REFERENCE: 26/0254

PROPOSAL: AGRICULTURAL GRAIN STORE

SITE: Fairwater Farm Began Road Cardiff CF3 6XS

APPLICATION TYPE: Prior notification

Footpaths shown

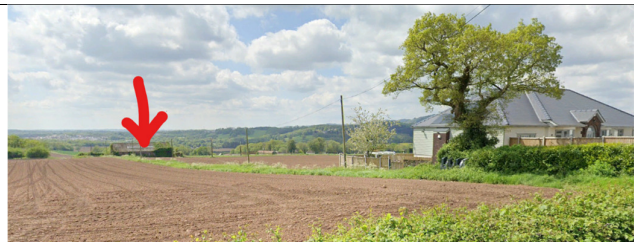
The application states the site is not visible from public footpaths but a route is shown running alongside the barn, this may be screened by existing hedges but this is not evidenced. Google Earth shows the site may also be visible from the highway although footage is taken at +2.5m above ground level.

I advise that the introduction of a new building at 8.6m to ridge height x 18.2m x 25.4m although replacing three buildings [although two may already have been demolished] would require a targetted landscape appraisal from points along the footpath in both directions and from the highway, leading to a plan showing protection of any screening vegetation and new planting as mitigation.
